PRODUCT BULLETIN

Manhole Ladder Type IAA Series FE8900

Manhole ladder FE8900 series Now with Hi-Vis rail protectors

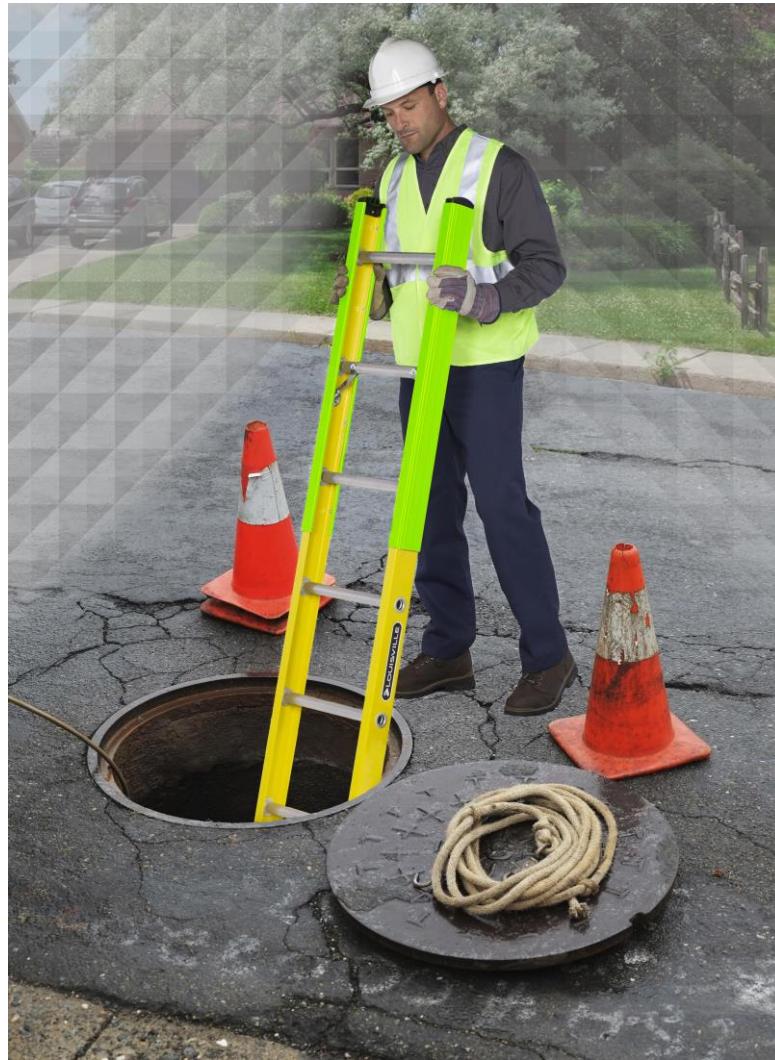
New *Hi-Vis* protectors on FE8900 Series
